**STAFF REPORT**  
**COMMUNITY DEVELOPMENT DEPARTMENT**

HEARING DATE: October 7, 2021  
 TO: Planning & Zoning Commission  
 FROM: Sonya Allen, Associate Planner  
 208-884-5533  
 SUBJECT: H-2021-0055  
 Southridge Apartments Phase 3  
 LOCATION: South of W. Overland Rd. and east of S. Ten Mile Rd., in the north ½ of Section 23, Township 3N., Range 1W. (Parcel #S1223120955)

Conditional Use Permit for a multi-family development consisting of 164 units on 9.07 acres of land in the R-15 zoning district.

## A. Site Plan (date: 8/4/2021)

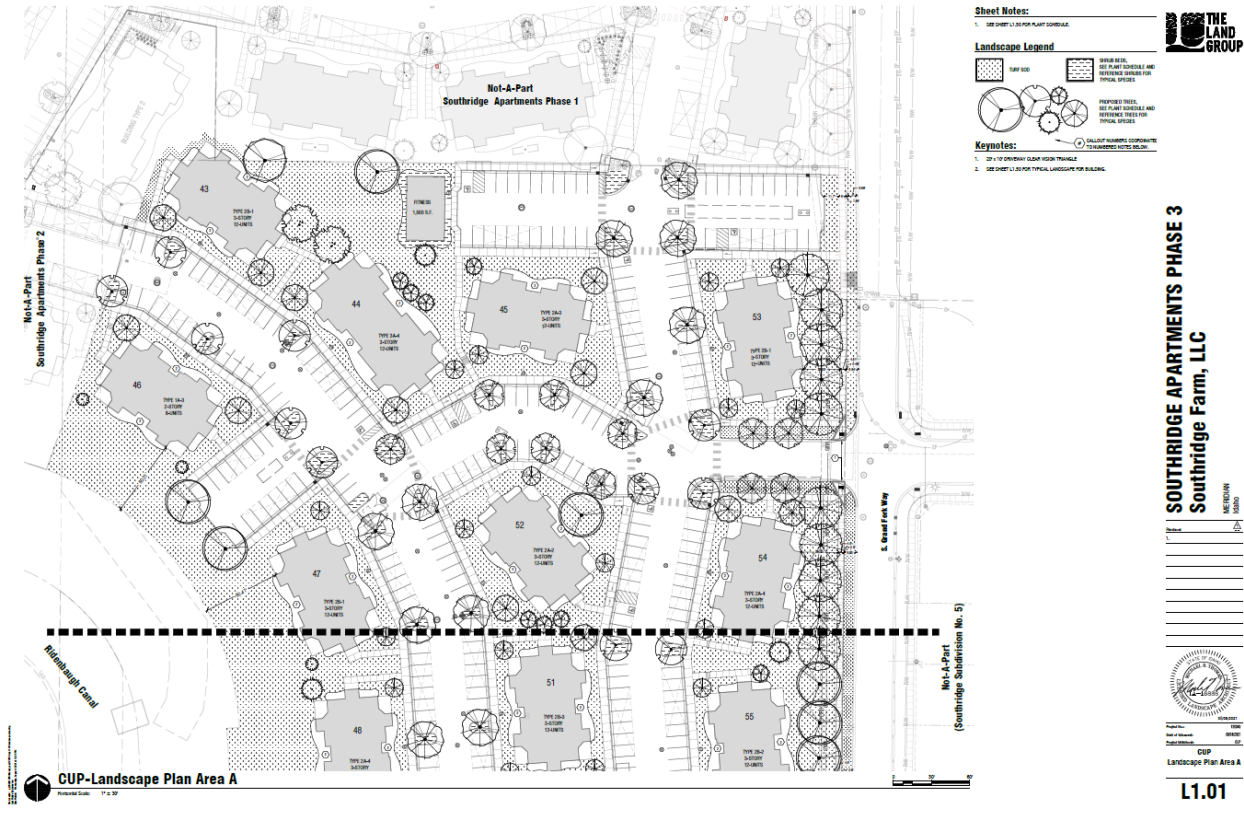
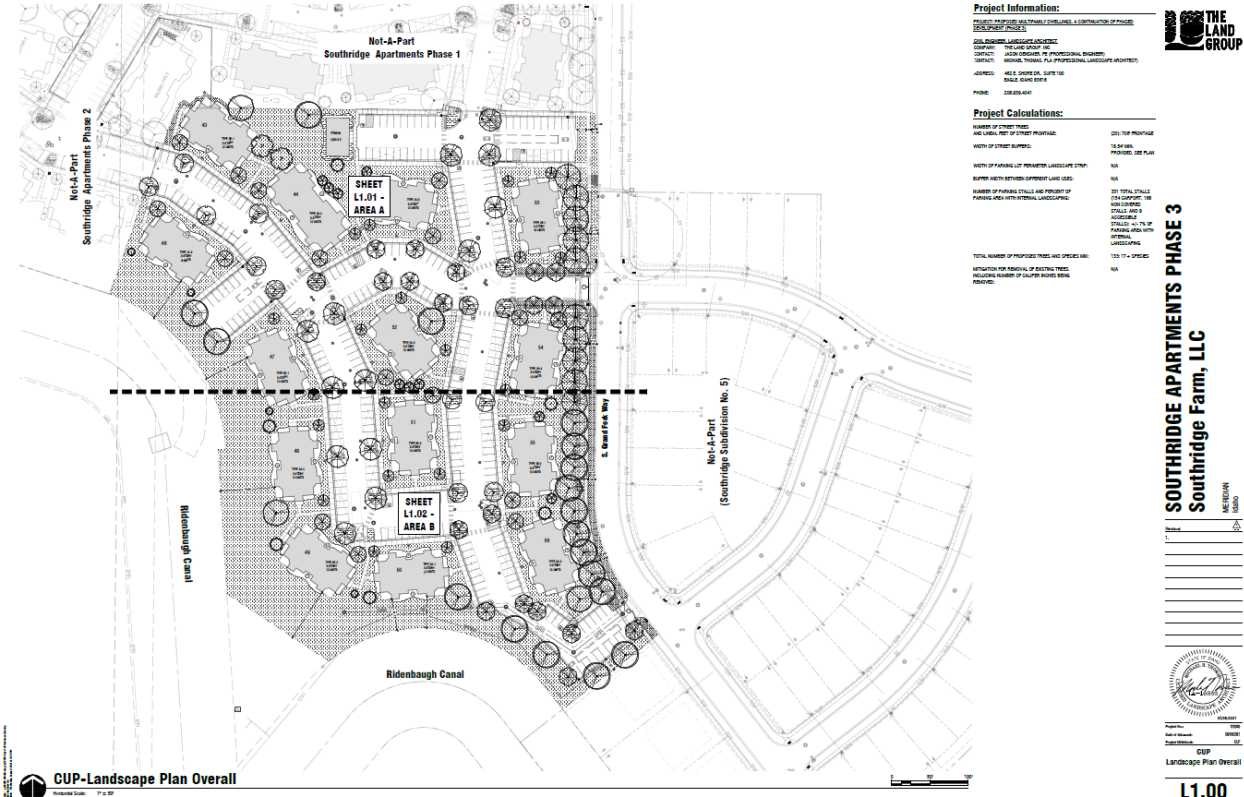
1. Buildings shall provide a minimum setback of ten feet (10') unless a greater setback is otherwise required by this title and/or [title 10](#) of this Code. Building setbacks shall take into account windows, entrances, porches and patios, and how they impact adjacent properties. ***Building #43 is depicted on the site plan over the north property line; the site plan needs to be revised to comply with the minimum setback requirement or a property boundary adjustment application should be requested to adjust the boundary of the property or consolidate the subject property with the property to the north.***

6. The parking shall meet the requirements set forth in [chapter 3](#), "Regulations Applying to All Districts", of this title. *Based on 79 1-bedroom units, 79 2-bedroom units and six (6) 3-bedroom units, a minimum of 289 off-street parking spaces are required with 164 of those being covered in a carport or garage; 165 uncovered spaces and 173 covered spaces are proposed for a total of 338 spaces, exceeding UDC standards. (Four additional uncovered spaces are proposed for Phase 2 and four carport spaces are proposed for Building 43 as noted on the site plan.)*

*Bicycle parking is required per the standards listed in UDC 11-3C-6G and should comply with the standards listed in UDC 11-3C-5C. One bicycle parking space is required for every 25 proposed vehicle parking spaces or portion thereof. Based on 338 spaces, a minimum of 13 spaces are required. The site plan notes each apartment building will be provided a bicycle parking area next to each entry point. **Bicycle parking in accord with UDC standards should be***

*noted on the site plan submitted with the Certificate of Zoning Compliance application; a detail of the bicycle rack shall also be depicted that complies with the standards listed in UDC 11-3C-5C.*

**Fencing:** No fencing is depicted on the landscape plan for this development. Any fencing constructed on the site should comply with the standards listed in UDC 11-3A-6 and 11-3A-7. **To preserve public safety, Staff recommends a 6-foot tall wrought iron fence is constructed on this site adjacent to the Ridenbaugh Canal.**

5. The site and/or landscape plan submitted with the Certificate of Zoning Compliance shall be revised as follows:
  - a. Building #43 shall be relocated to comply with the minimum setback standard in UDC Table 11-2A-7 and 11-4-3-27; or, a property boundary adjustment application should be submitted to consolidate the subject property with the property to the north or to adjust the boundary of the property.

- b. Bicycle racks shall be depicted next to the entries of each building. At a minimum, 13 spaces shall be provided per UDC 11-3C-6G; a detail of the bicycle rack shall also be depicted that complies with the standards listed in UDC 11-3C-5C.

- g. Depict 6-foot tall wrought iron fencing adjacent to the Ridenbaugh Canal to preserve public safety.
6. A street light plan will need to be included in the building permit and/or final plat applications. Street light plan requirements are listed in section 6-7 of the City's Design Standards. A copy of the standards can be found at [http://www.meridiancity.org/public\\_works.aspx?id=272](http://www.meridiancity.org/public_works.aspx?id=272) .

B. Landscape Plan (dated: 8/4/21)

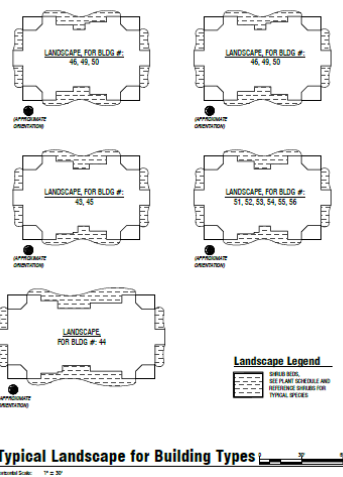
***The landscape plan submitted with the Certificate of Zoning Compliance application should depict landscaping along the street facing elevations adjacent to S. Grand Fork Way in accord with these standards.***

**Landscaping is required within common open space areas per the standards listed in UDC 11-3G-3E. Calculations should be included in the Project Calculations table demonstrating compliance with this standard.**

- d. Depict landscaping along the foundations of all street facing elevations adjacent to S. Grand Fork Way as set forth in UDC 11-4-3-27E.2.
  - e. Depict landscaping within parking lots in accord with the standards listed in UDC 11-3B-8C.

- f. Landscaping is required within common open space areas per the standards listed in UDC 11-3G-3E. Calculations should be included in the Project Calculations table demonstrating compliance with this standard.
